**MODELS 47G-3B & 47G-3B-1  
 MAINTENANCE AND OVERHAUL INSTRUCTIONS  
 TEMPORARY REVISION 47-15-2**

REFERENCE: Alert Service Bulletin 47-15-27

**SAFETY WIRING OF THROTTLE CONTROL LINKAGE ASSEMBLY**

Figure 5-11. Throttle Control Installation

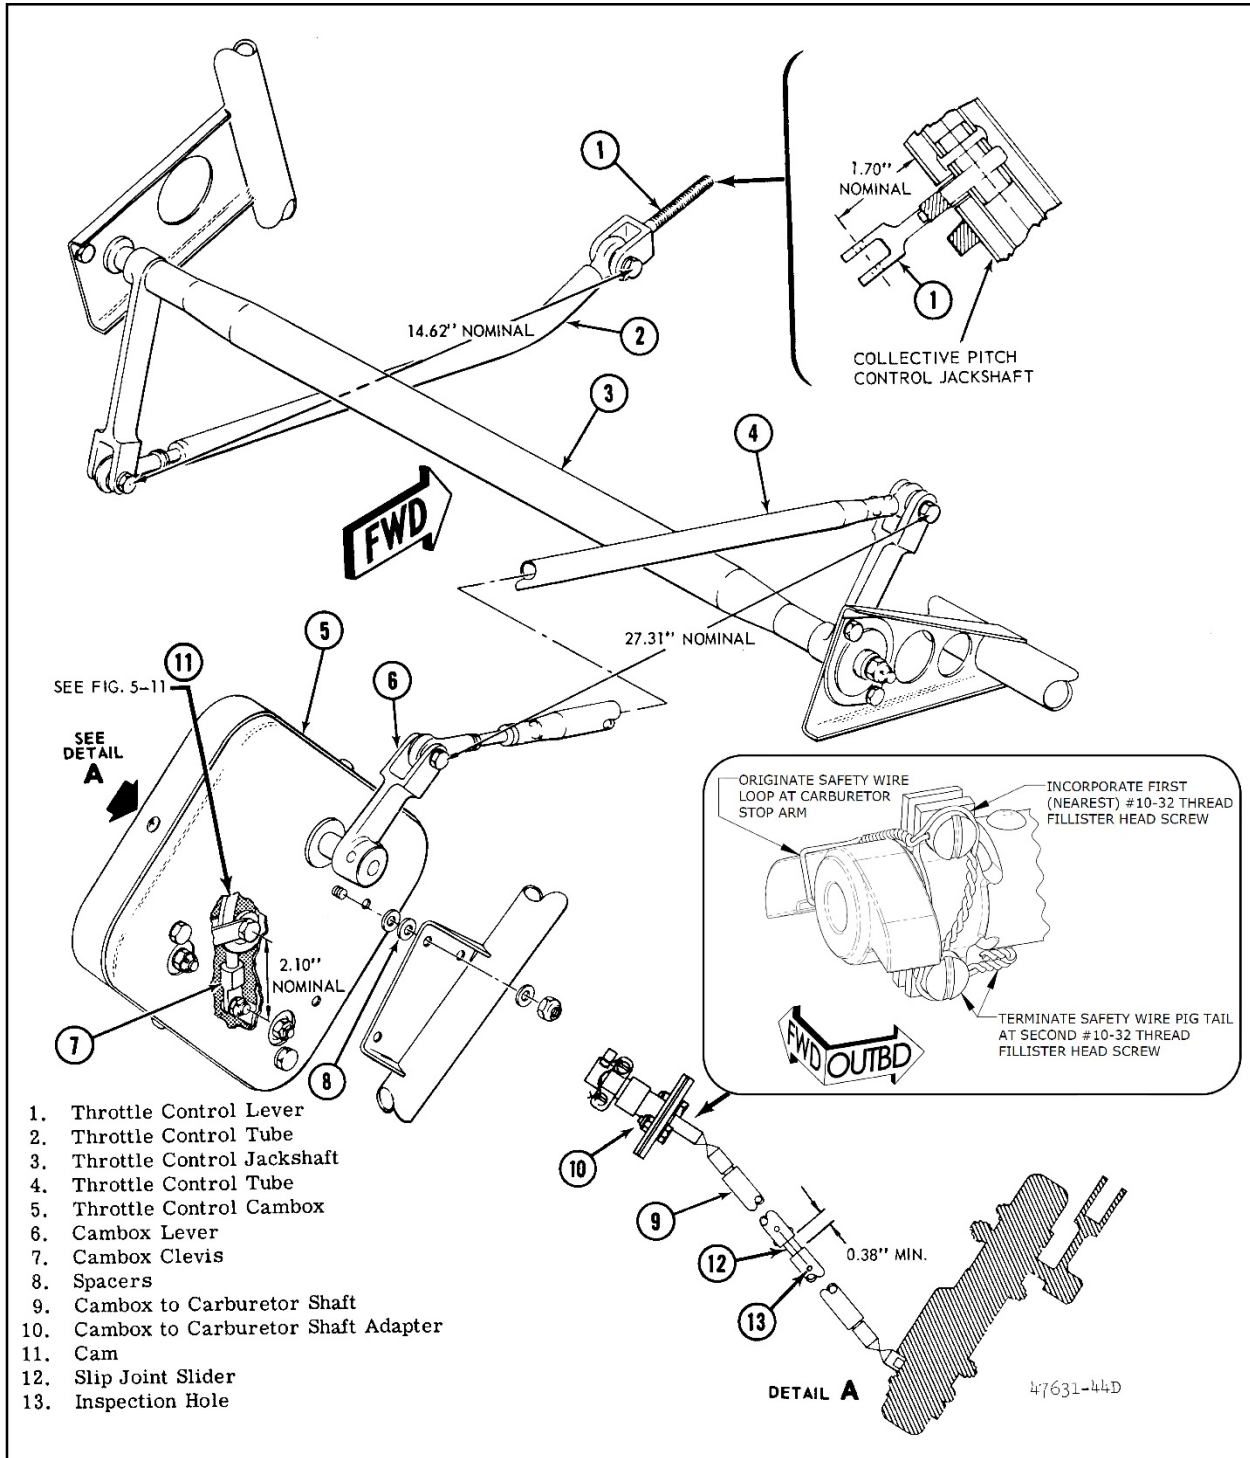
REASON: To improve integrity check of the throttle linkage assembly and graphically clarify proper safety wire installation of the throttle linkage assembly.

- Section V, Page 5-16, Rev 3, 1 December 1974  
 Revise Figure 5-11 as shown on page 2 of this Temporary Revision:
